ROUTE 9A - WEST STREET PROMENADE PROJECT  
 RECONSTRUCTION OF RT. 9A-WEST ST. (BATTERY PLACE TO CHAMBERS ST.)  
 MANHATTAN, NEW YORK COUNTY

FIELD CHANGE SHEETS (JUNE 6, 2012)

BATTERY PARK UNDERPASS APPROACH WALLS MODIFICATIONS

**BATTERY PARK UNDERPASS APPROACH WALLS GENERAL NOTES**

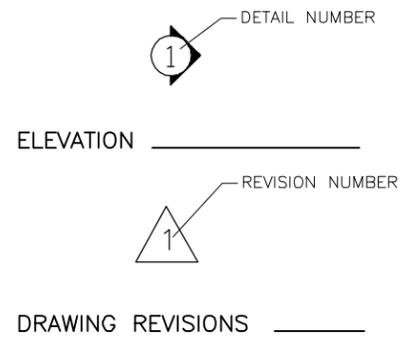
1	ADDED AND MODIFIED NOTES AND ADDED TABLE	05/08/2012
NO.	DESCRIPTIONS	DATE
REVISIONS

11. REFER TO THE LANDSCAPE NOTES ON DWG. NO. LSN-01 REGARDING TREE/VEGETATION PROTECTION AND STOCKPILE/STAGING/STORAGE AREAS WHEN ACCESSING THE WEST WALL FROM THE PLANTER AREA.

12. THE FULL-SIZE SAMPLE WALL PANEL SHALL NOT BE SHIPPED UNTIL ALL PANELS ARE FABRICATED AND ACCEPTED BY THE NYS DOT-9A LANDSCAPE ARCHITECT. PROCUREMENT OF MATERIALS THAT COMPLY WITH SPECIFICATION REQUIREMENTS MAY PROCEED IN ADVANCE OF ACCEPTANCE OF SAMPLE WALL PANEL.

1 GROUND LEVEL PLAN AT B.P.U. PORTAL EXTENSION AND APPROACH WALLS

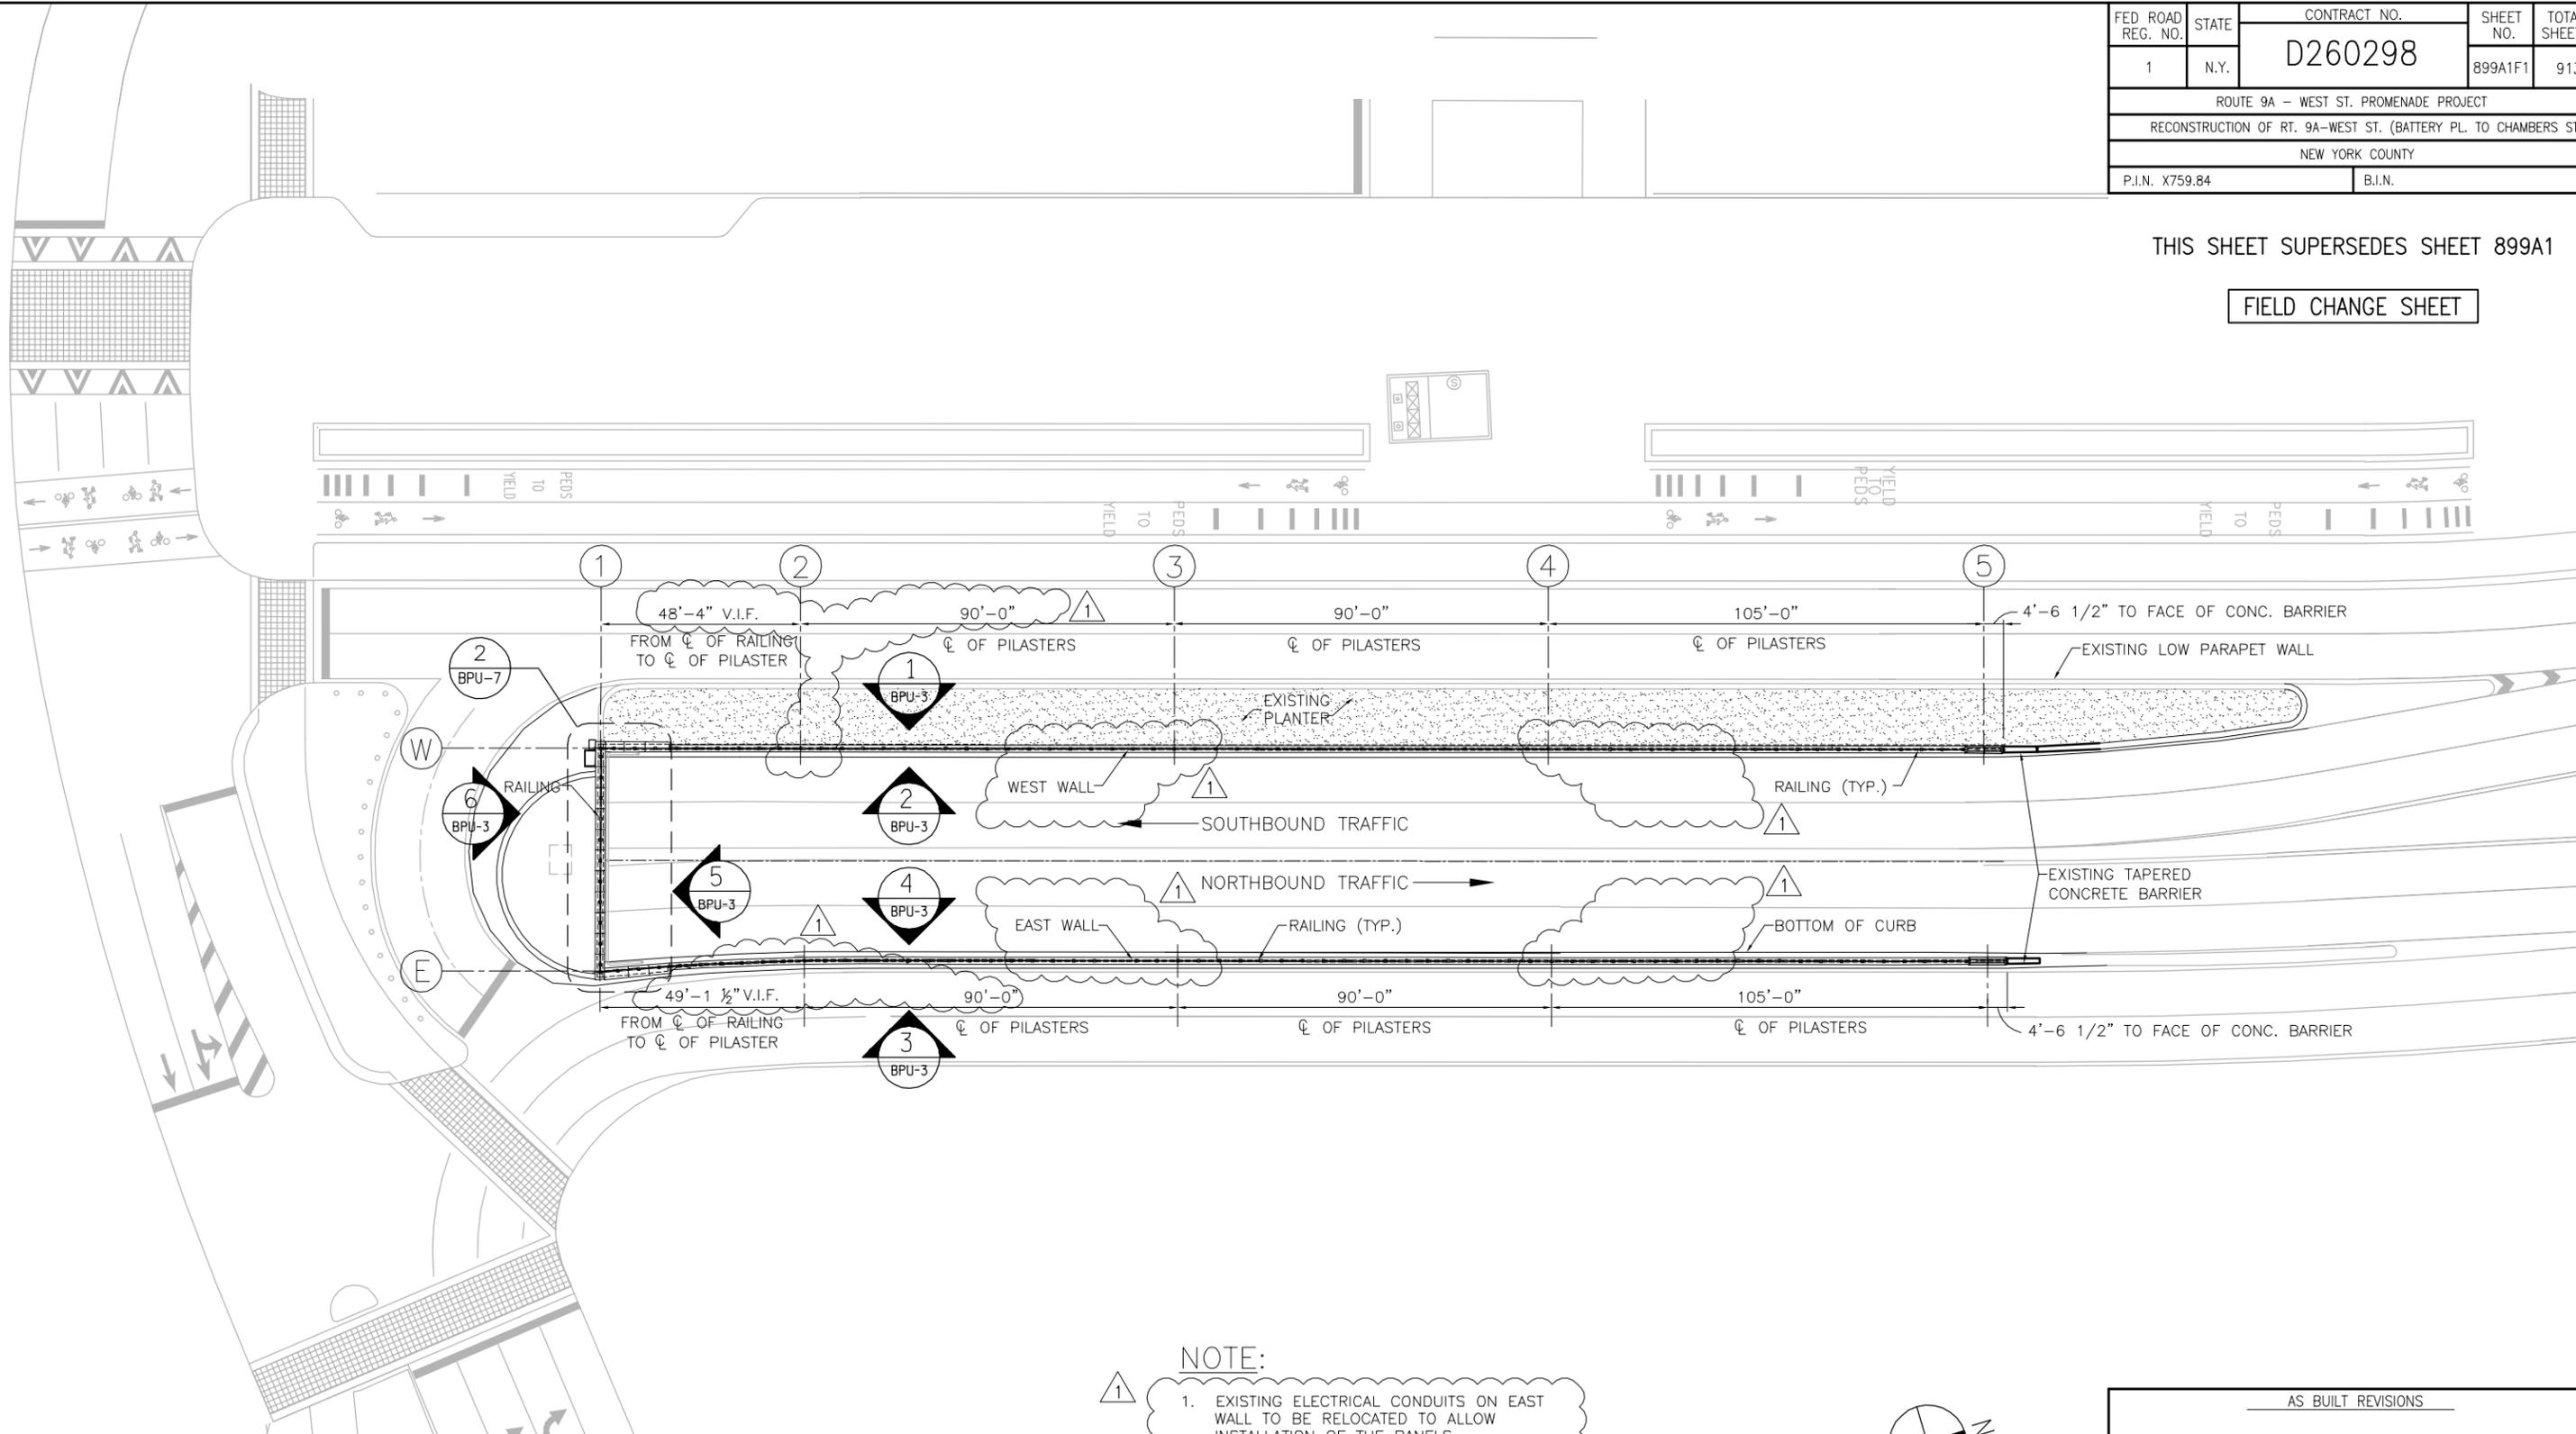
NO.	DESCRIPTIONS REVISIONS	DATE
1	REVISED NOTE AND PLAN, DELETED PILASTER HEADS	05/08/2012

**NOTE:**  
 1. EXISTING ELECTRICAL CONDUITS ON EAST WALL TO BE RELOCATED TO ALLOW INSTALLATION OF THE PANELS.

**BATTERY PARK UNDERPASS  
APPROACH WALLS  
WALL ELEVATIONS**

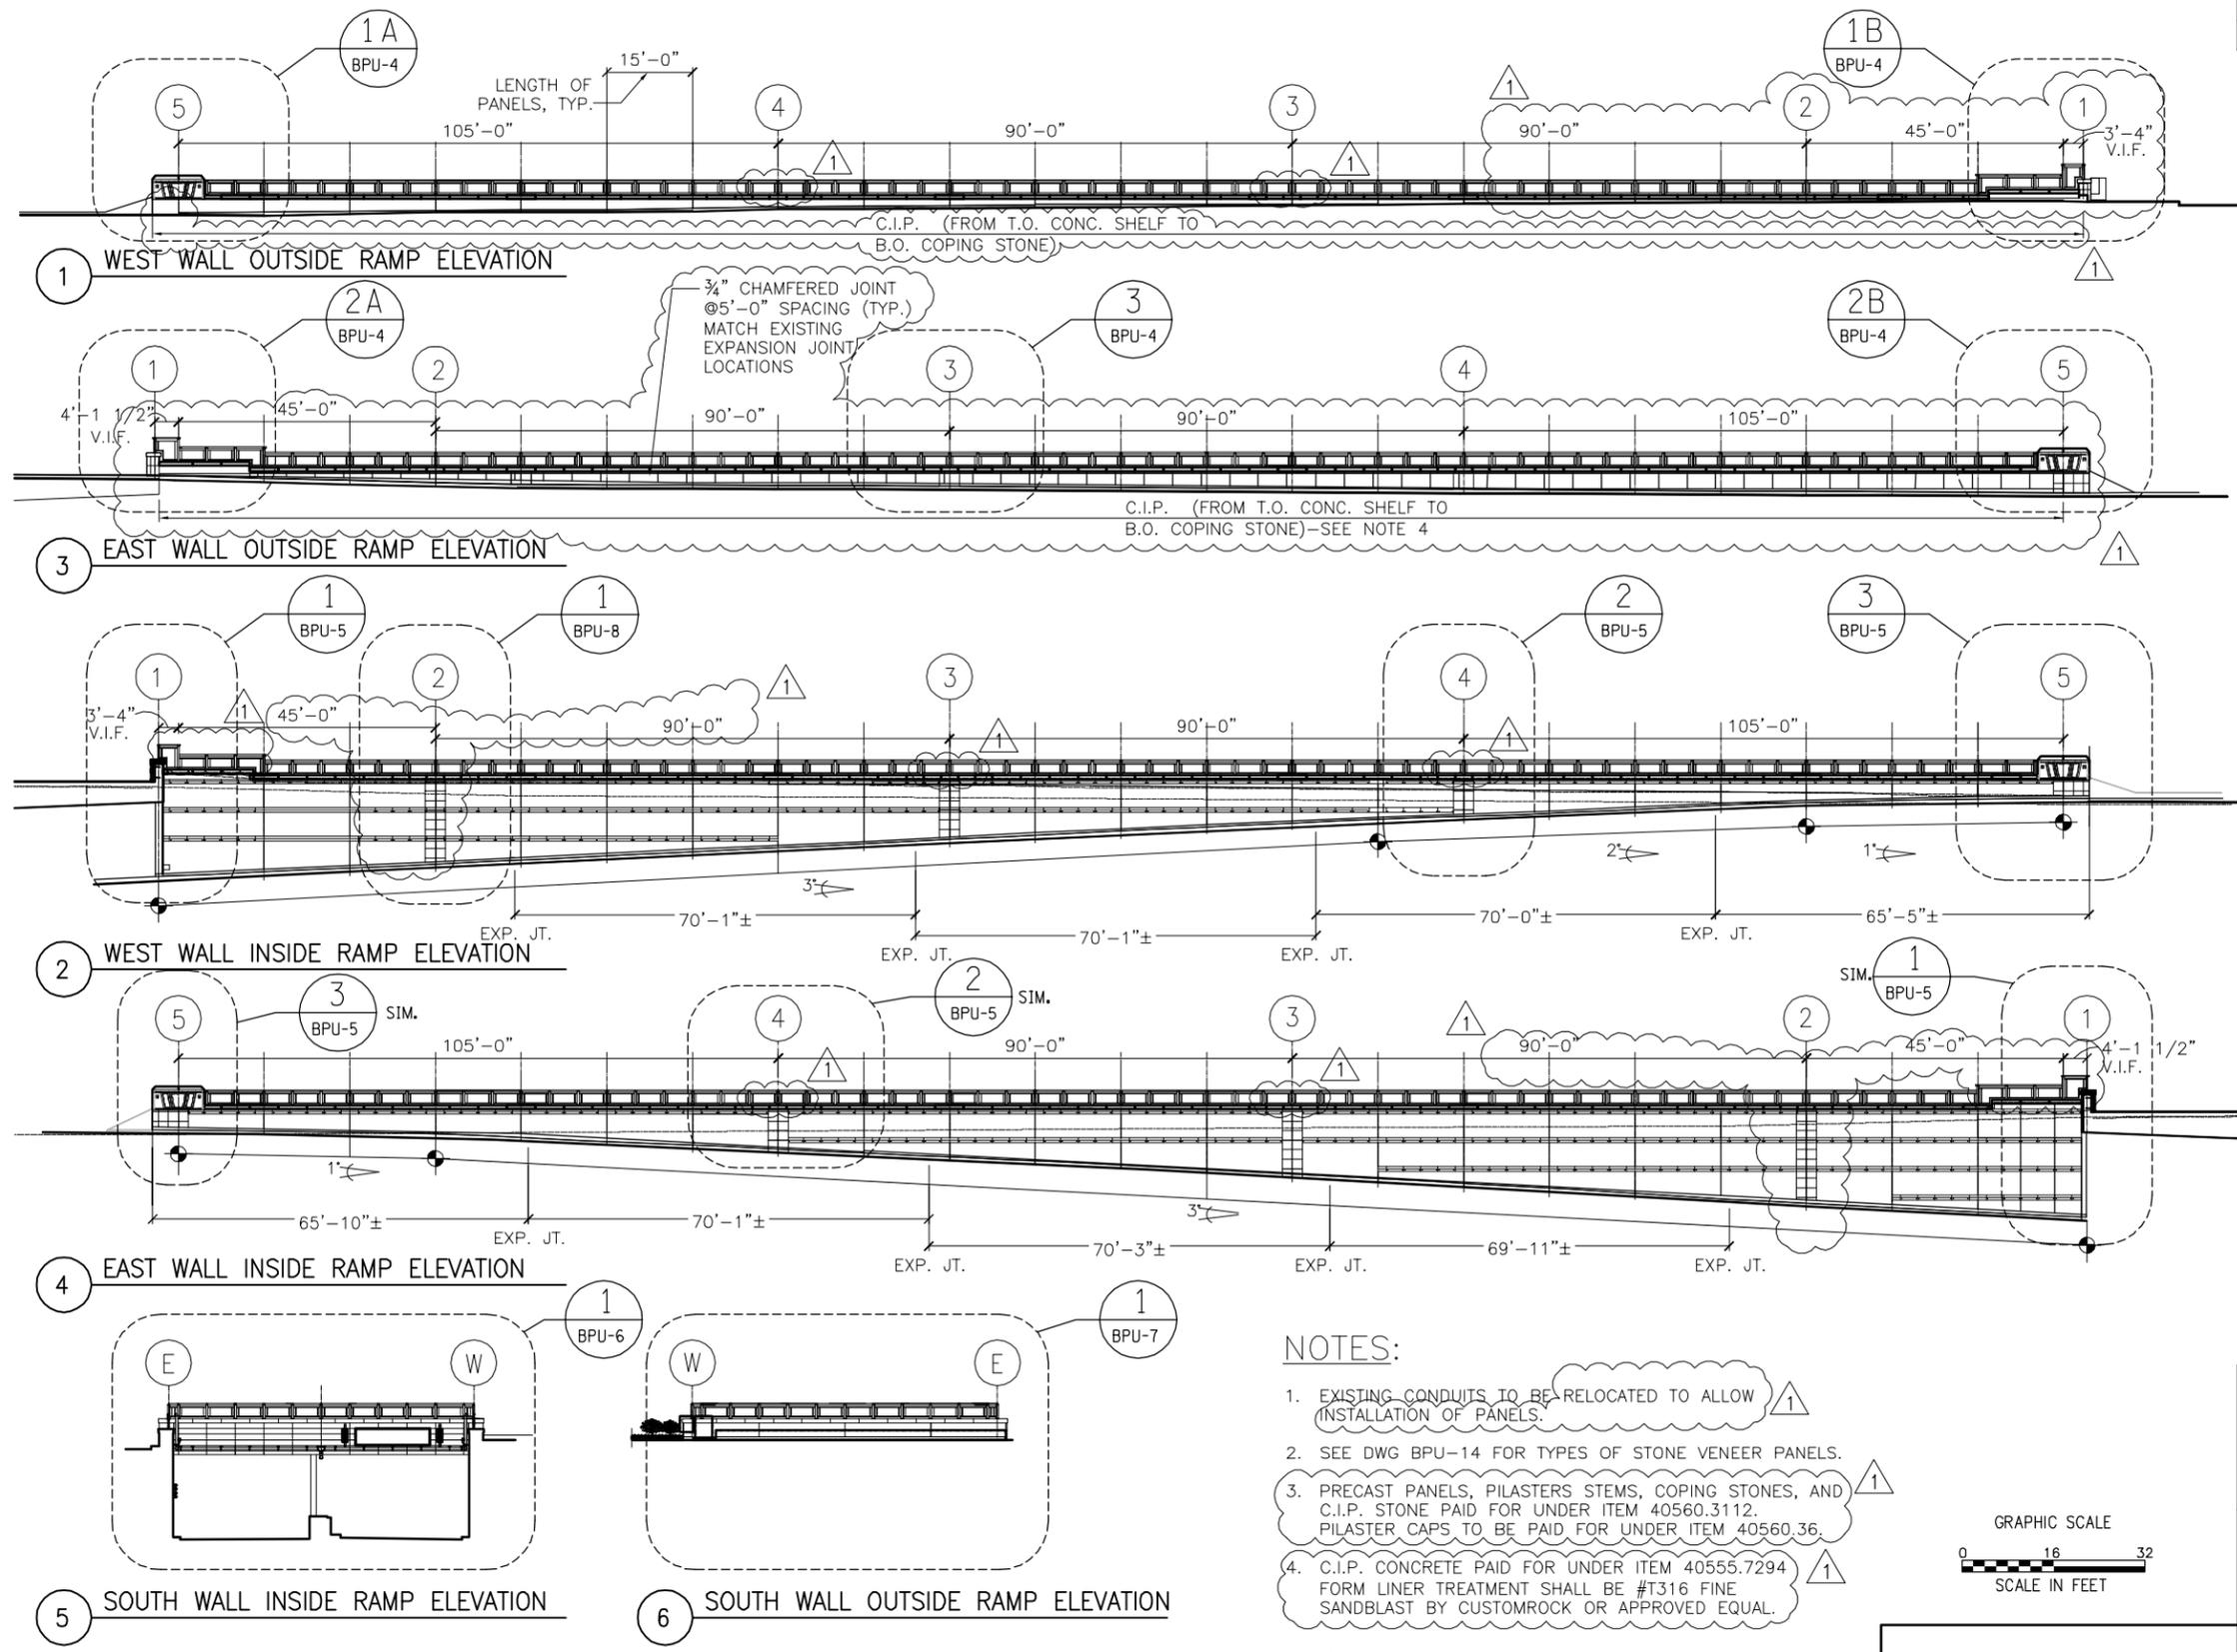
NO.	DESCRIPTIONS	DATE
1	ADDED NOTE, CHANGED TO C.I.P. CONCRETE, DELETED PILASTER HEADS	05/08/2012
	REVISIONS

- EXISTING CONDUITS TO BE RELOCATED TO ALLOW INSTALLATION OF PANELS.
- SEE DWG BPU-14 FOR TYPES OF STONE VENEER PANELS.
- PRECAST PANELS, PILASTER STEMS, COPING STONES, AND C.I.P. STONE PAID FOR UNDER ITEM 40560.3112. PILASTER CAPS TO BE PAID FOR UNDER ITEM 40560.36.
- C.I.P. CONCRETE PAID FOR UNDER ITEM 40555.7294. FORM LINER TREATMENT SHALL BE #T316 FINE SANDBLAST BY CUSTOMROCK OR APPROVED EQUAL.
